File 1994-0004

Name: Alpine Village -Final Plat / Plan -SW Corner of 27 Road & G Road

TITLE HEADING: Final Plat/Plan - Alpine Village

Title: ALPINE VILLAGE, Final Plat/ Plan

Comment: PAN AND DRAINAGE SWALE / SECTION A-A

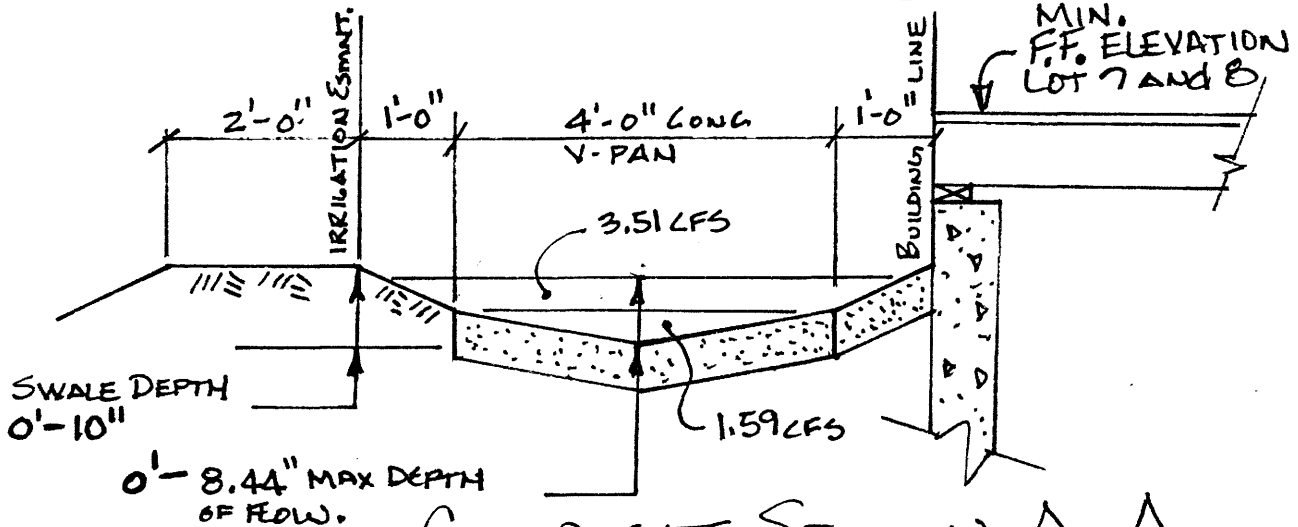
Show the 100 year flow elevation along the valley pan. Also, cross-sections of the pan and grading need to be provided. Can the irrigation and utility easement be modified for drainage, since it appears some drainage will encroach on this easement?

III. Cross sections of the proposed 4'-valley pan have been added to Sht. No. ST-1, ST-2 and the drainage plan. The valley pan, drainage easement and swale section have been modified to accommodate the 100 year storm.

ALPINE VILLAGES - TYP. TURNING MOVEMENT @ PRIVATE DRIVE

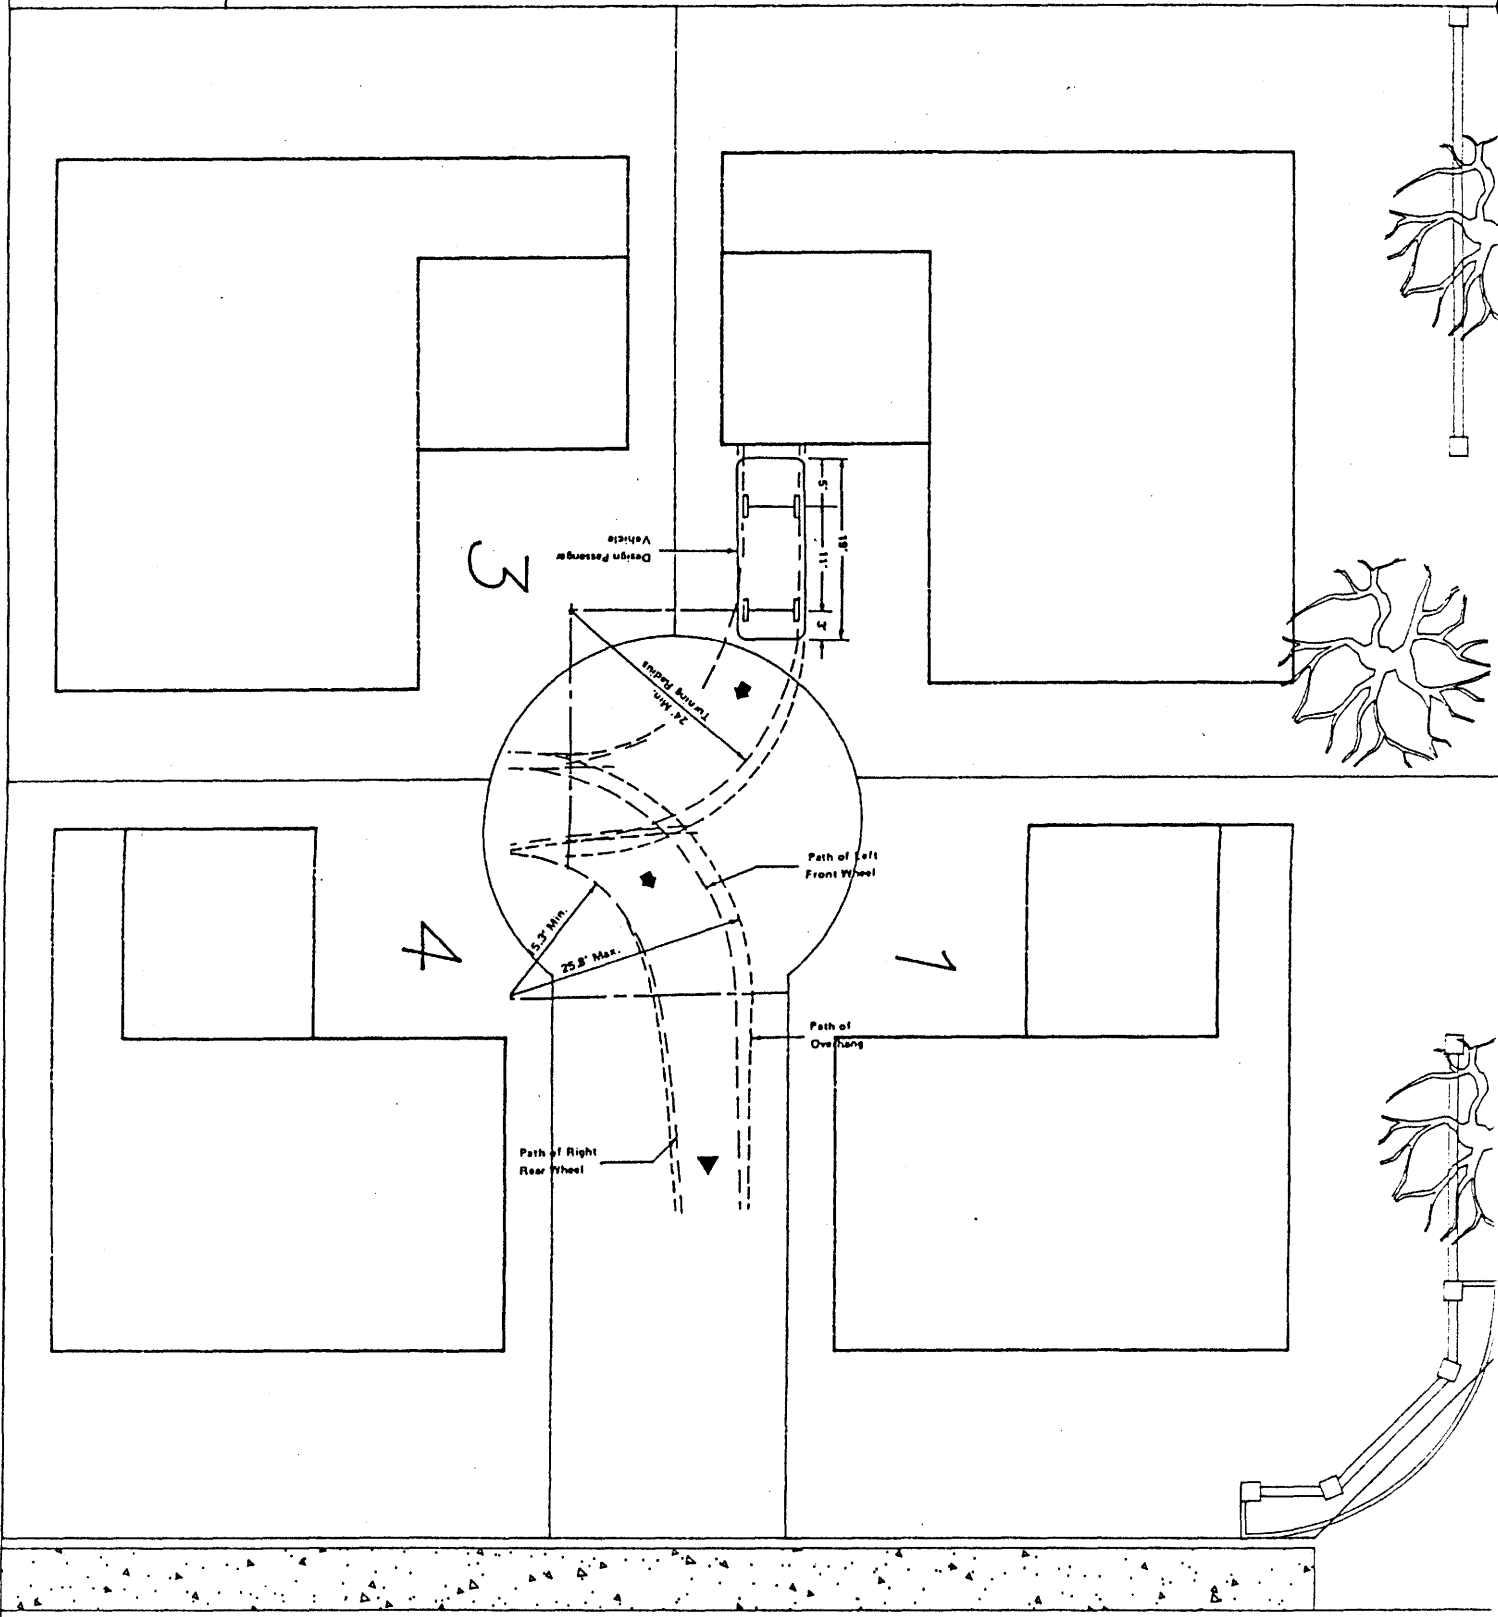
Please show a construction detail of the private drives. The pavement design submitted says it is for the main drive areas - does that include the private drives? The private drives need to accommodate the turning manuevers of a passenger car. At turning template for a passenger car is attached.

1. Driveway construction details have been added to the Site Development Plan.

LANDSCAPE PLAN	
ALPINE VILLAGE	
TAL THOMAS A. LOGUE LAND DEVELOPMENT CONSULTANT	
PROJECT NO. C:\TAL\ALPINE\93109	SHEET OF
DATE: AUGUST, 1993	LS-1 1

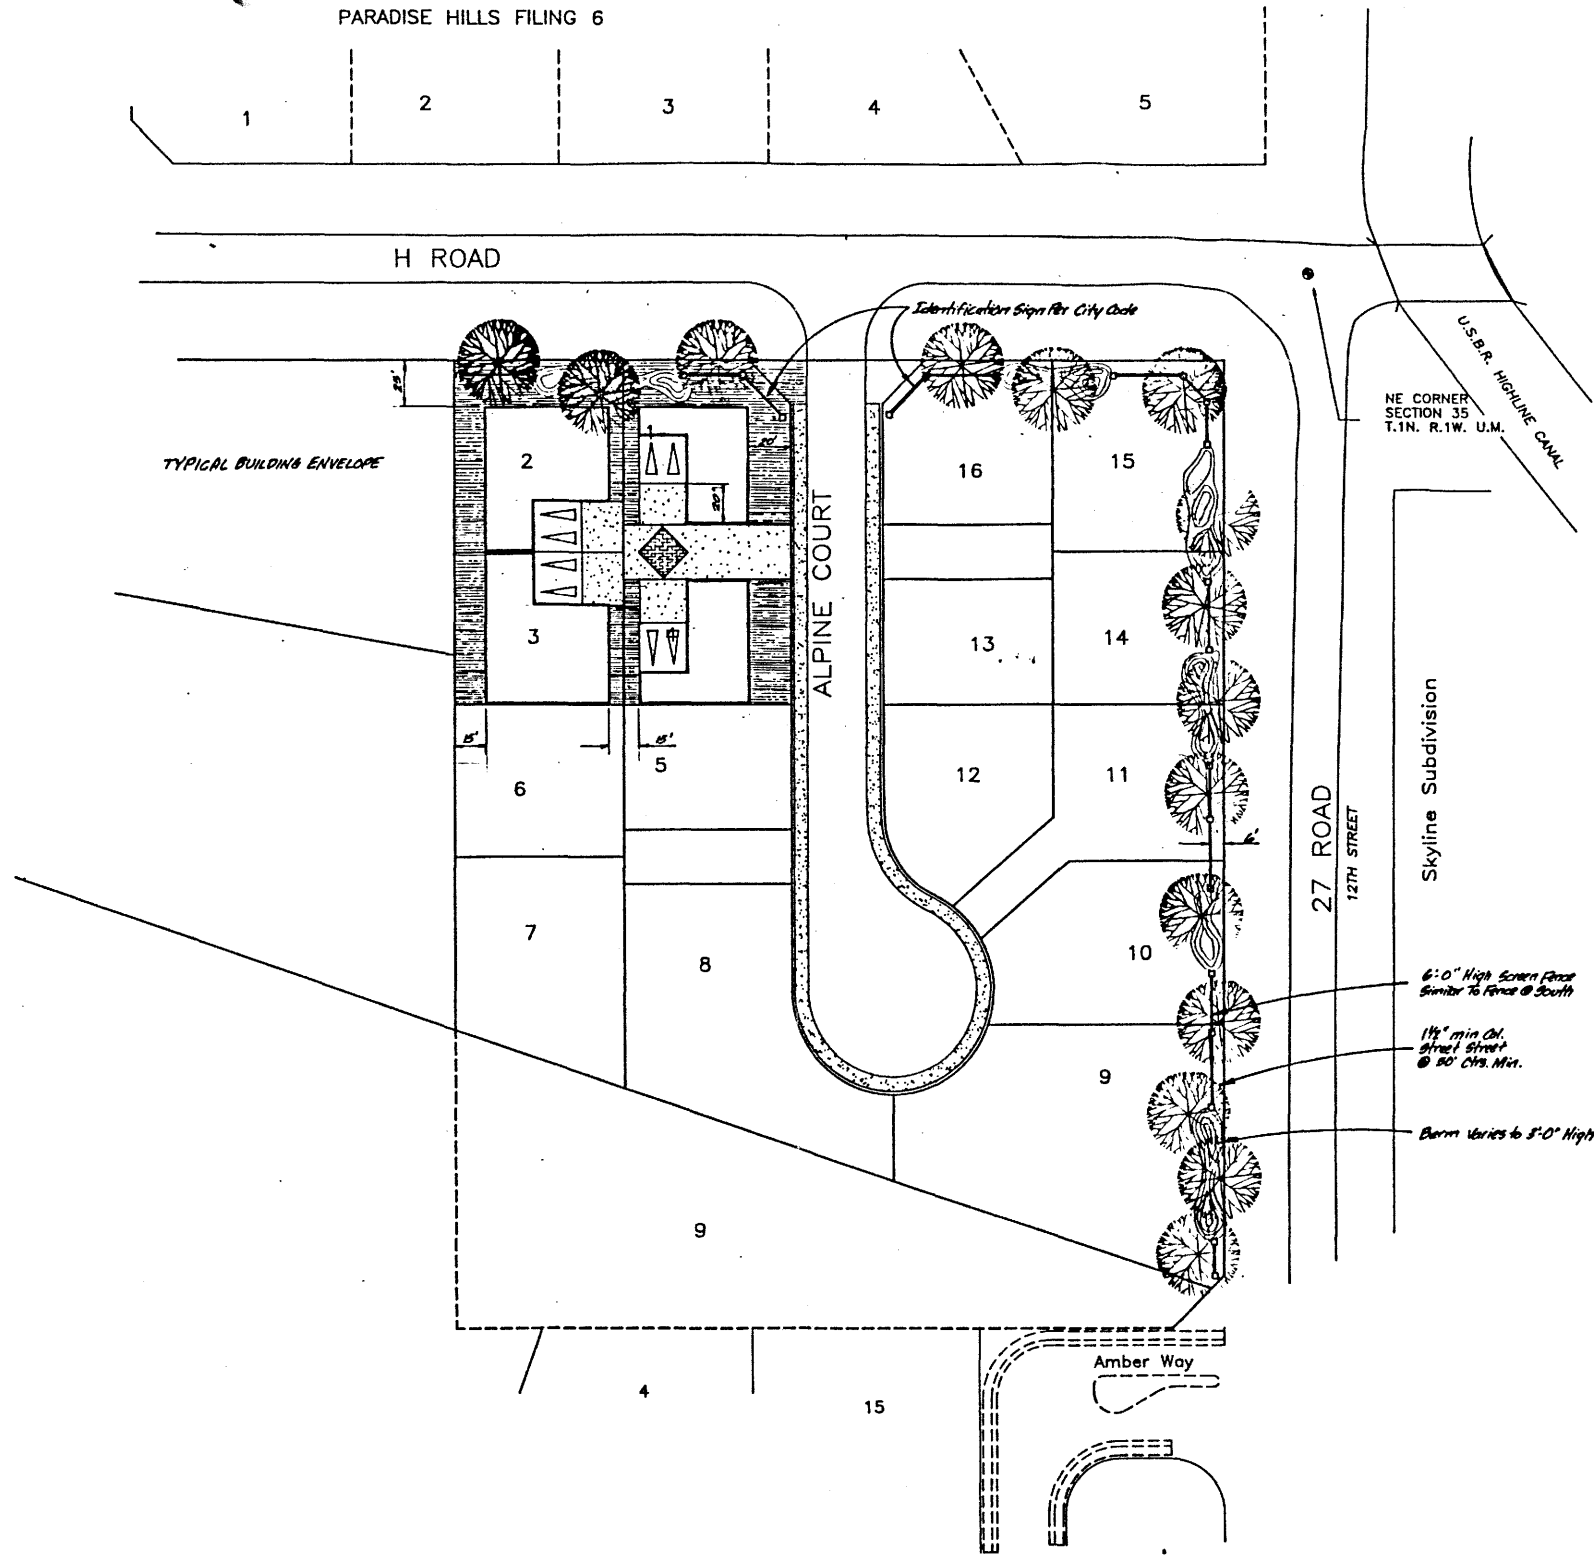
Landscape Plan: The auto court looks like it poses difficulties to lots 2&3 for access. Do they back over the neighbor's lawn? Back all the way to the street? Some explanation of maneuverability would be helpful.

3. A chart indicating the Minimum Setback Requirements is on the Final Plat.
4. A Plot Plan depicting the location of each building foot print is attached. The plan indicates how traffic movements will occur at the ends of the auto courts.
